Subject: Final Rule, Response to Petitions for Reconsideration, Technical Amendment, Docket No. 2008-0111, Anthropomorphic Test Devices; ES-2re Side Impact Crash Test Dummy 50th Percentile Adult Male.

First Technology Safety Systems (FTSS) has reviewed the February, 2008, ES-2re dummy drawing package (identified in the above mentioned technical amendment) and we have identified a number of drawing errors and a number of drawing issues. We seek to petition NHTSA to correct these drawings to ensure that the ES-2re dummy continues to meet the same dimensional and performance requirements established for the dummy when the dummy was proposed for inclusion into 49 CFR Part 572 Subpart U. FTSS makes the following comments and recommendations with respect to the drawing package. A marked up drawing for each of these recommended changes are attached to the end of this letter.

ITEM NO.	QTY	PART NO.	DESCRIPTION
PART LIST			
UNITS ARE millimeters			NATIONAL HIGHWAY TRAFFIC SAFETY ADMINISTRATION
MATERIAL REF. STEEL 080M40			
SCALE 1.000			TOP PLATE UNLC BLANK
APPROVALS		DATE	
DRAWN		CHECKED	SIZE A3 SHEET 1 OF 1 DRAWING NUMBER 175-1011 REV. A
ENGINEER

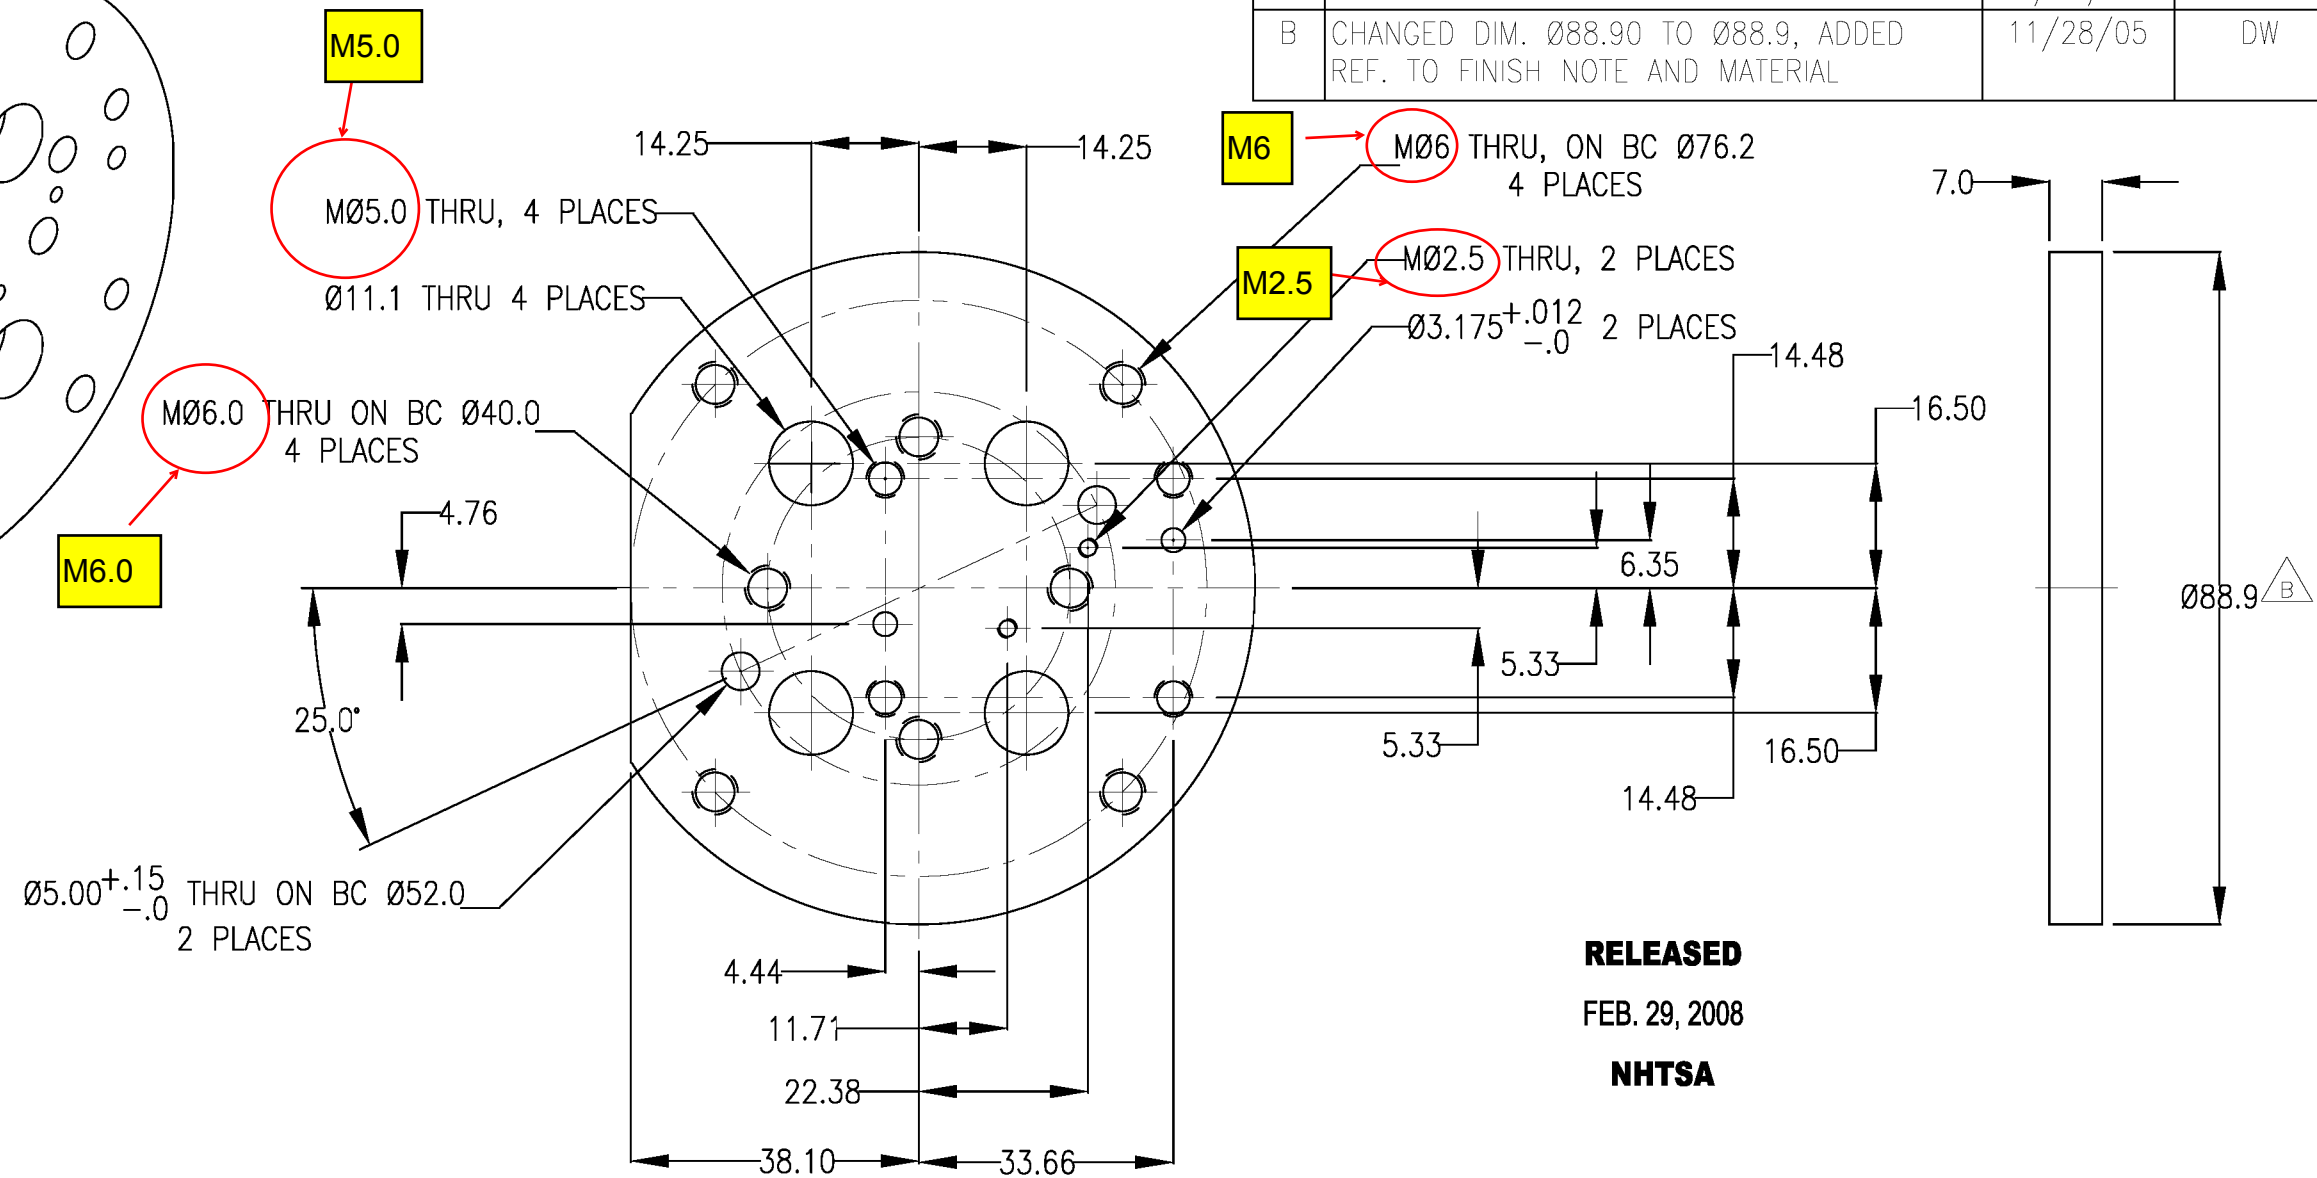
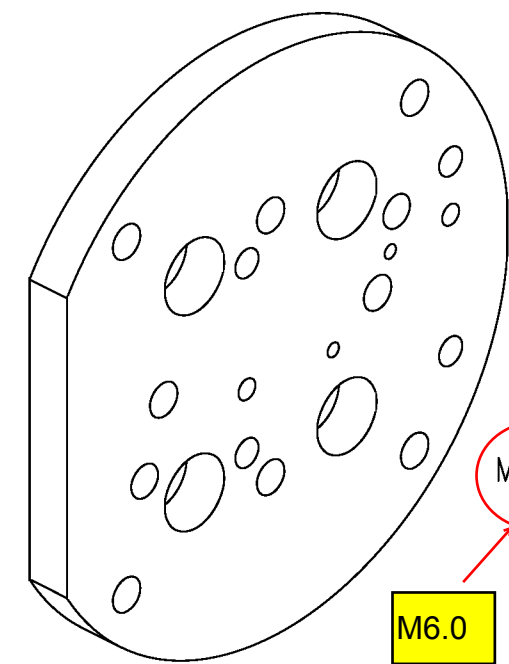
- 1) Drawing 175-1011, Top Plate UNLC Blank. Fix typographical errors for dimensions, MØ5.0, MØ6.0, MØ6, and MØ2.5. Eliminate the Ø symbol.
- 2) Drawing 175-3502, Pivot Stop Plate, Left. Fix typographical error on Note #4. Replace RH with LH since this is a left hand part.

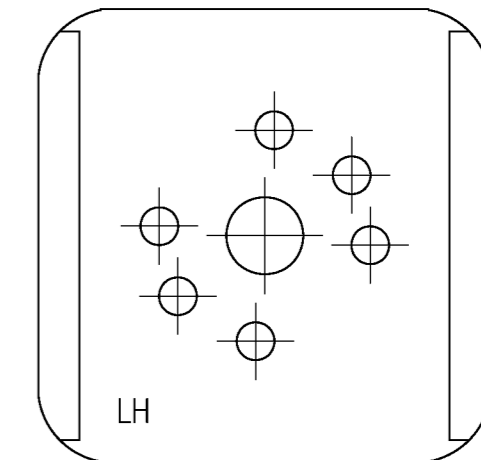
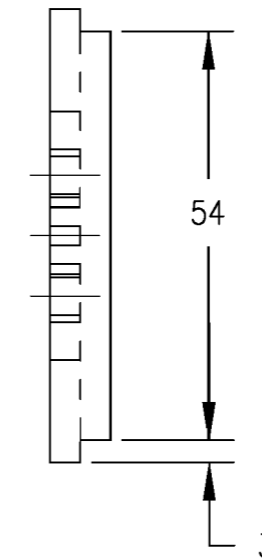
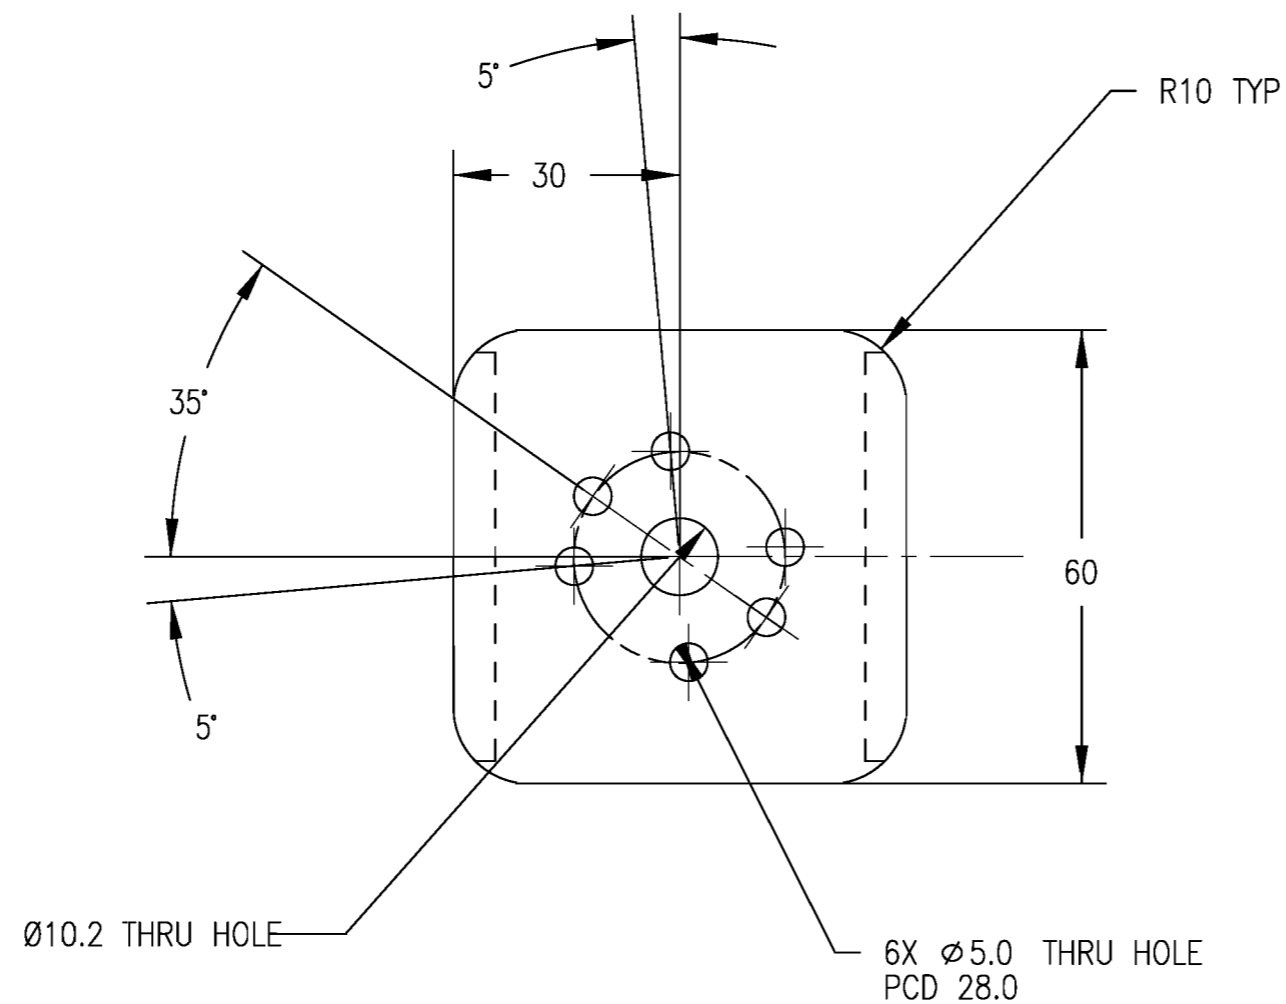
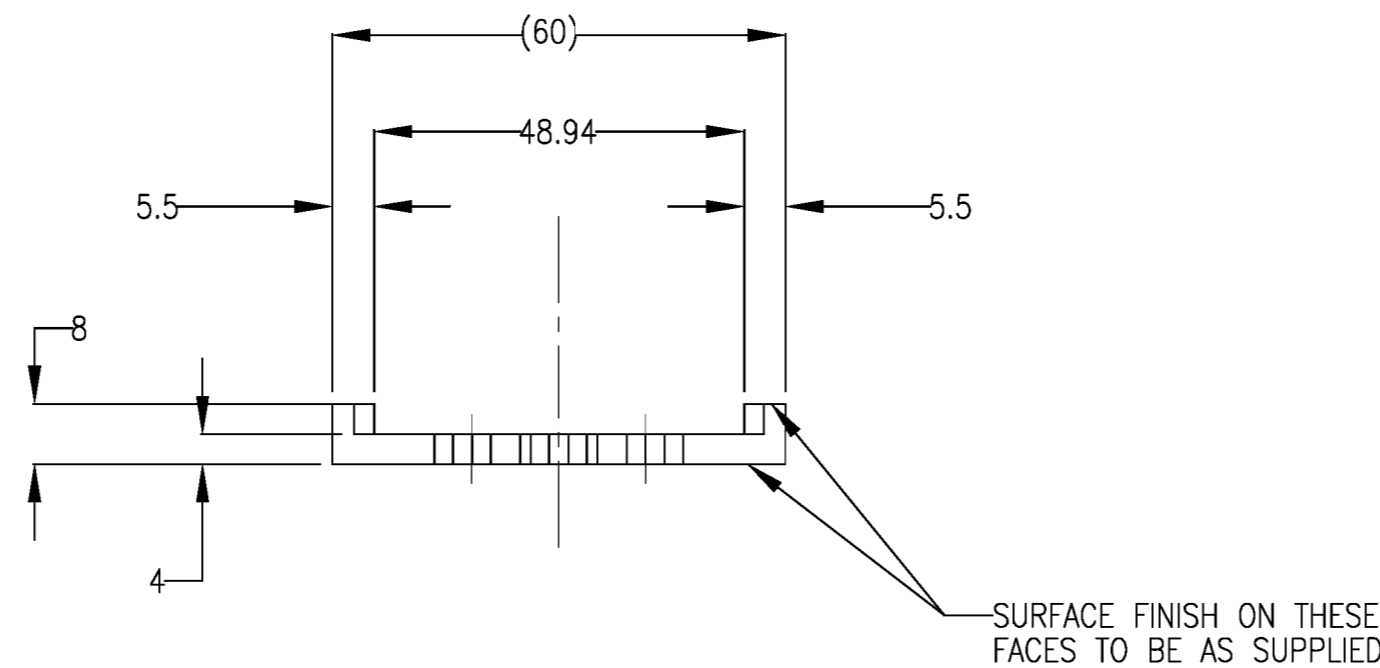
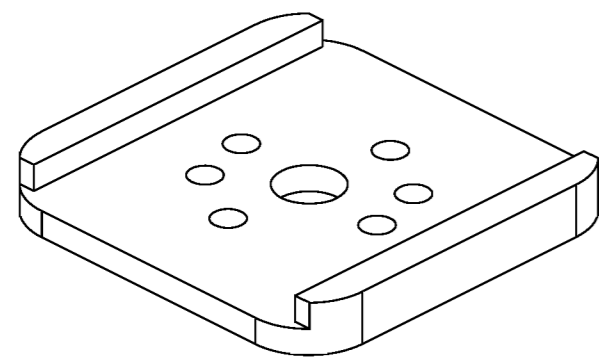
"LH"

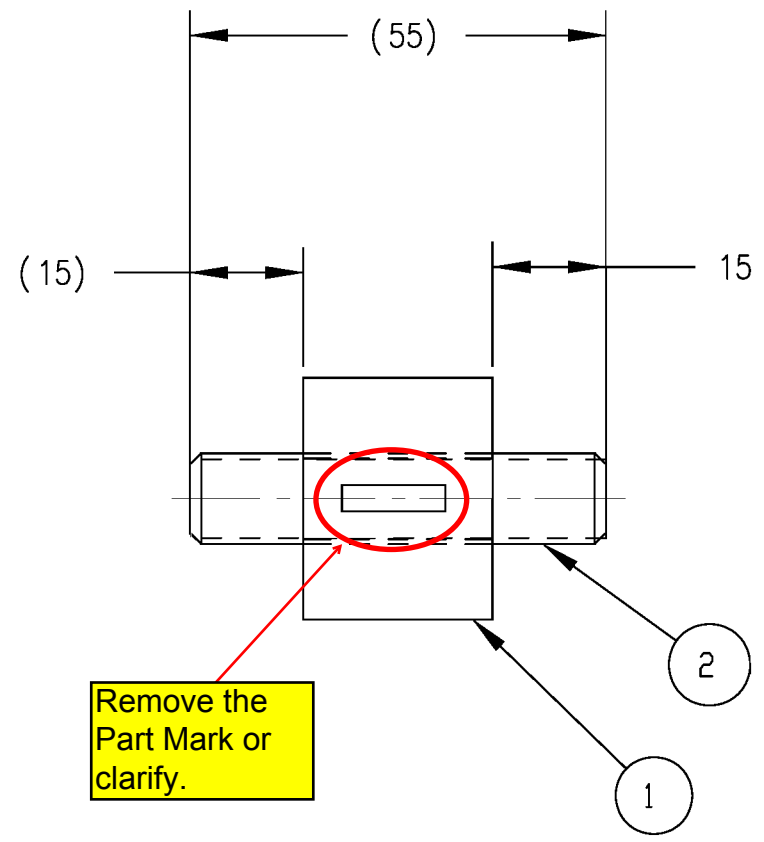
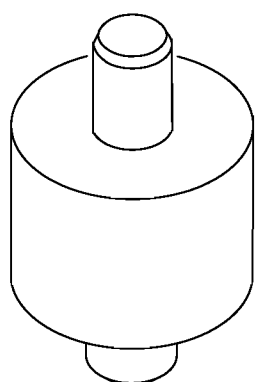
- 3) 175-6006, Pubic Symphysis Structural Replacement. There is a Part Mark located at the center of the part. This Part Mark is not defined. FTSS recommends that the Part Mark be clarified or removed altogether from the drawing.

Remove the Part Mark or clarify.

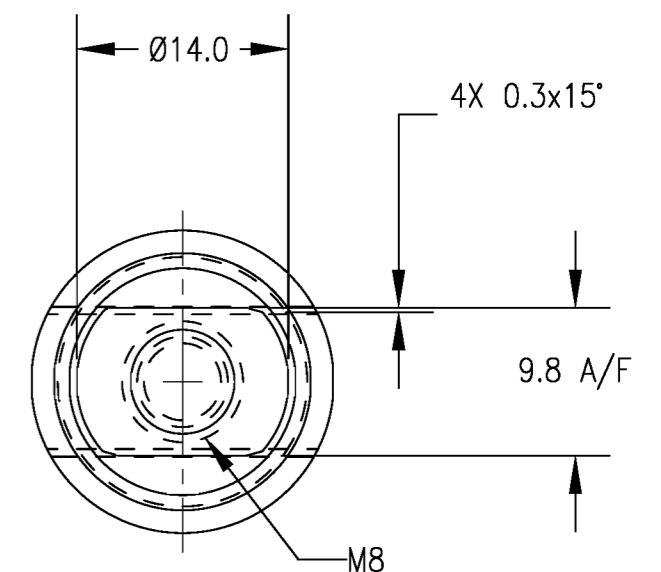
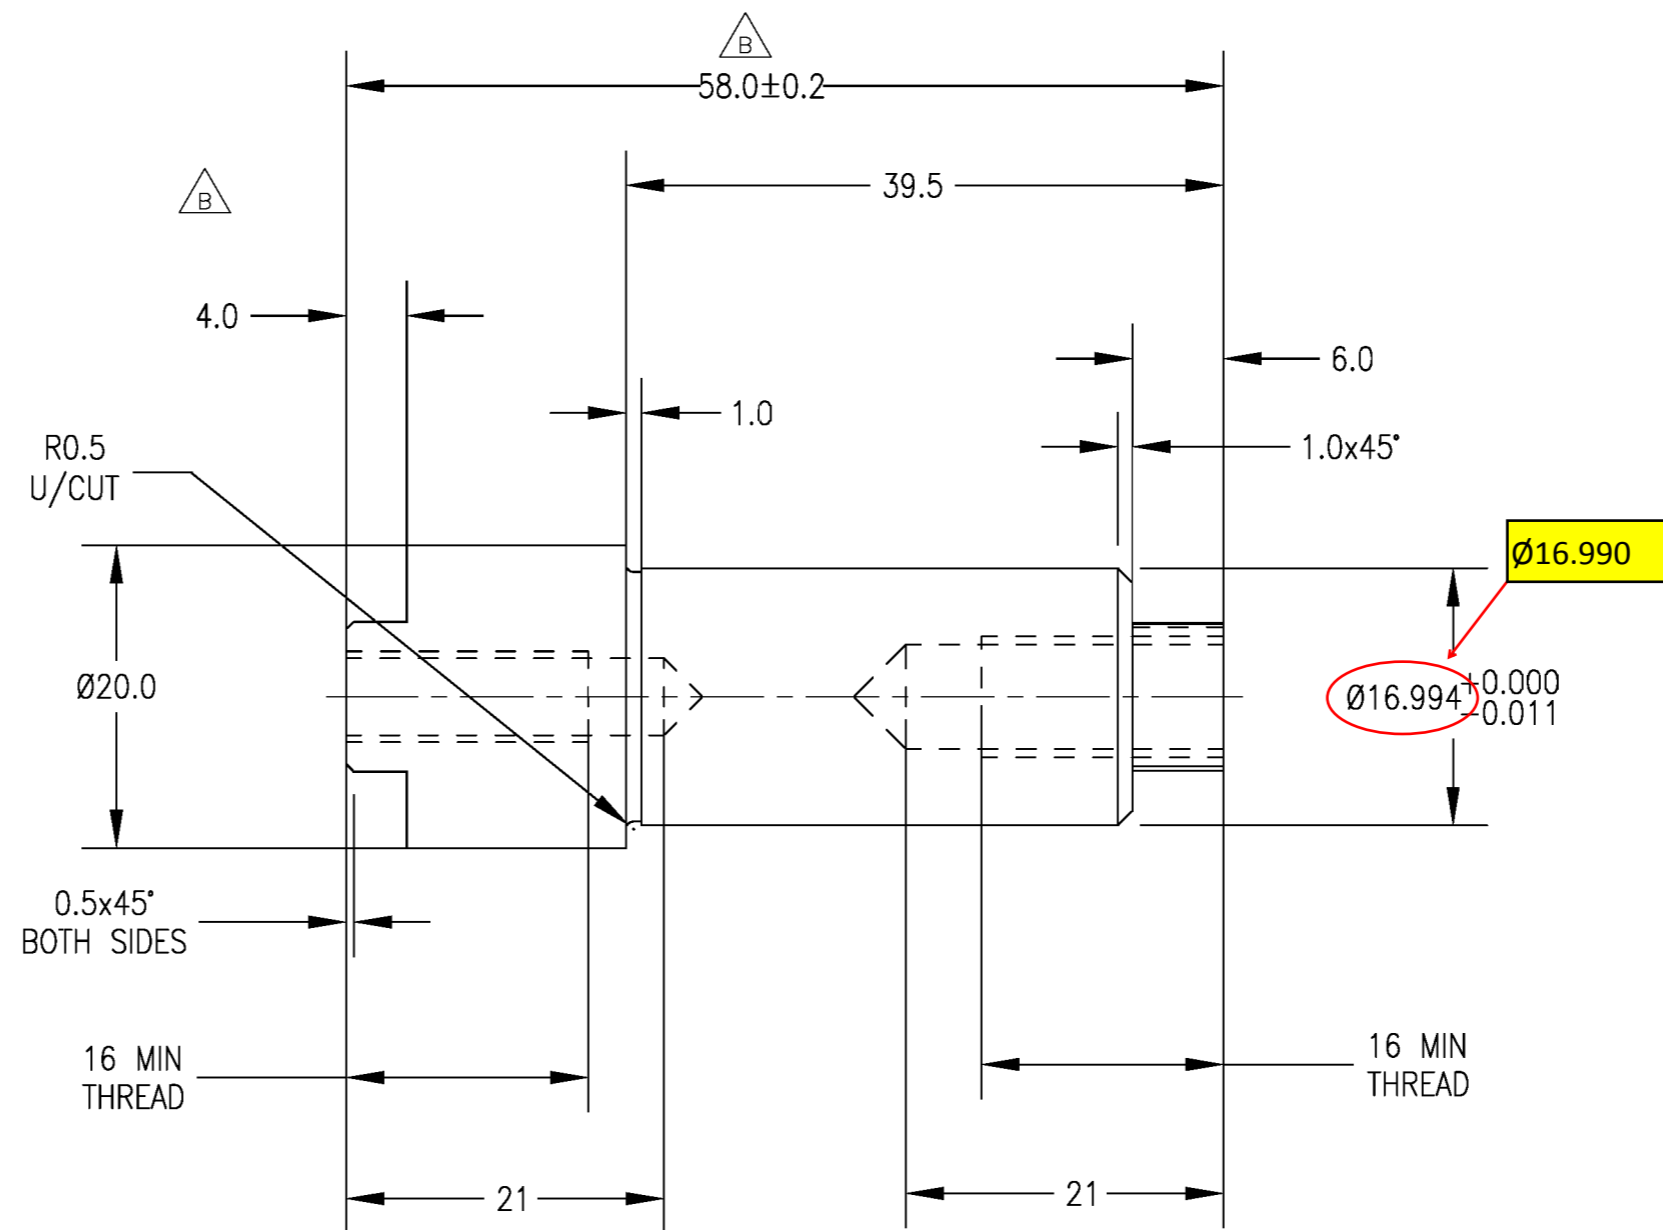
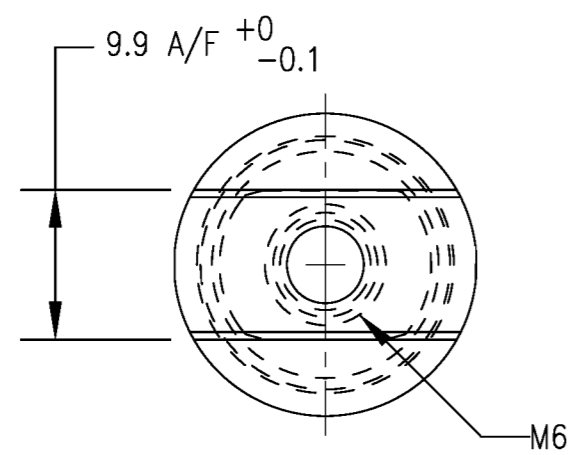
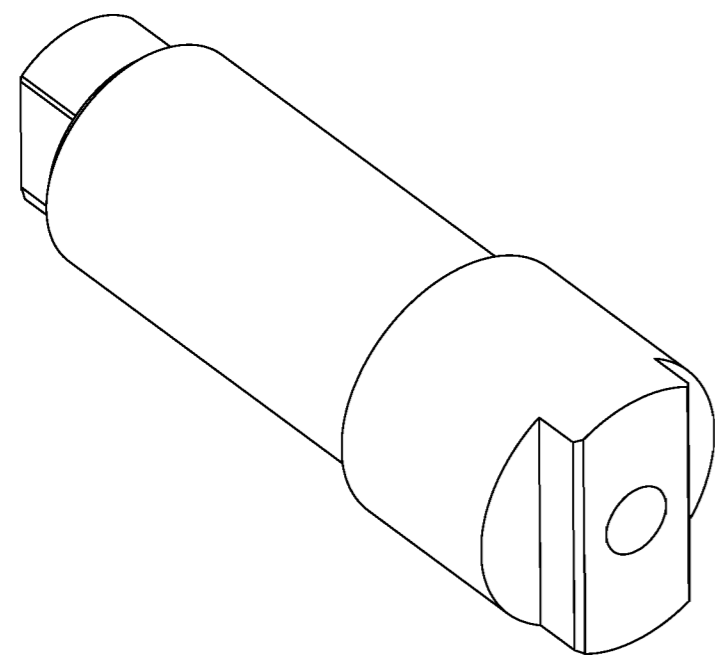
- 4) Drawing 175-6012, Hip Pivot Pin. FTSS believes that dimension "16.994 +0.000 / - 0.011" is a typographical error and should be dimensioned as "16.990 +0.000 / -0.011". The Hip Pivot Pin mates to part number 5000110 (Ball Bearing) – which has an ID dimension of 17.000 +0.000 / -0.008 (vendor specification). The bearing at a nominal dimension of 16.992 would not allow a Hip Pivot Pin at its maximum diameter of 16.994 to fit within the bearing.
